Black Horse 7 Fed Com 1H Fire (1RP-5511), Lea

A question regarding the Closure Report for: Black Horse 7 Fed Com 1H Fire (**1RP-5511**) Lea:

Surface Water Protection Map
Black Horse 7 Fed Com 1H - Monahan Oil
Sec. 7 T20S R31E, Lea County, New Mexico

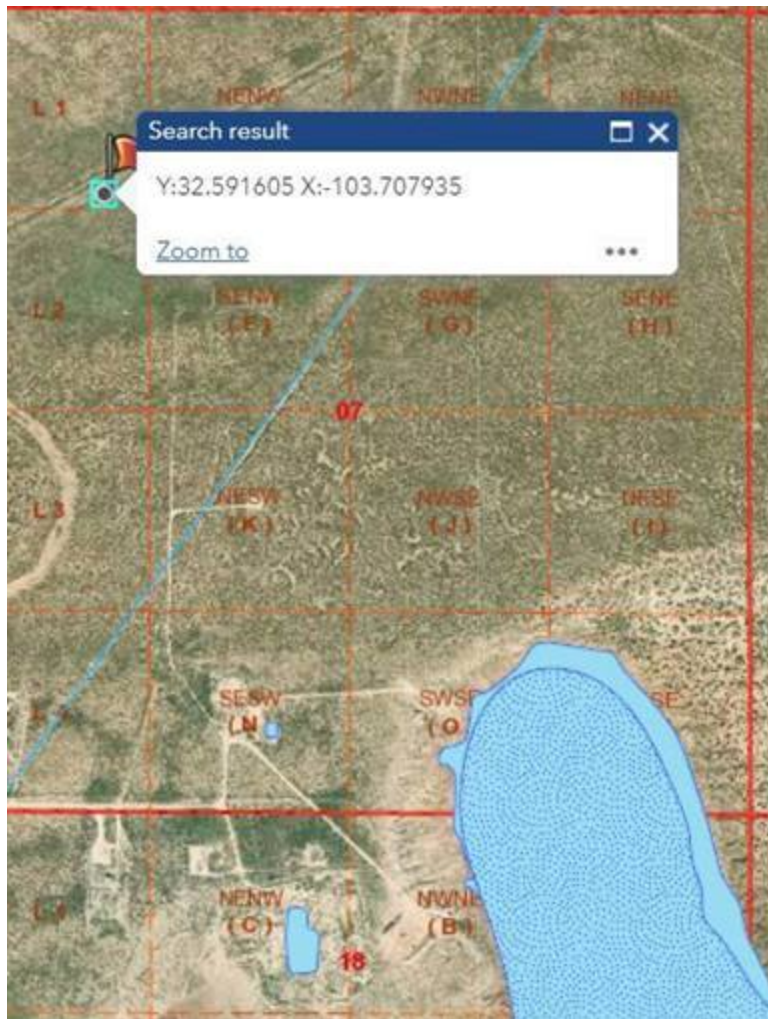
- In Figure 1 and Figure 2, the point of release is located approximately 500 feet West of Laguna Gatuna.

- The lat/long coordinates provided in form C-141 are: 32.59160463, -103.70793500. As you can see in the figure below (NMOCD Environmental Map), this location does not correspond with the point of release depicted in the closure report. Can you please clarify the actual location, the Lat/Long coordinates, of the release source?

Hope all is well. I don't have your number otherwise I would have called as it might have been easier to explain over the phone. I was forwarded this email from Ashley Maxwell with SM&A. Heather is no longer working for SM&A and Ashley Maxwell has taken over as project manager. Callie (also no longer working for Marathon) seems to have submitted the coordinates to the actual well head of the Black Horse 7 Fed Com 1H. The flare and tanks are located on the Green Frog Café Fed Com 1H well pad. I can see where the confusion is as the report references the Green Frog Café Fed Com 1H well pad that's closer to Laguna Gatuna. I can change the C-141 forms to show the correct coordinates if that's ok with you? If so, would I just need to email the corrected Closure Report to you or re-submit on the OCD website? I'm sorry for any confusion this might have caused.
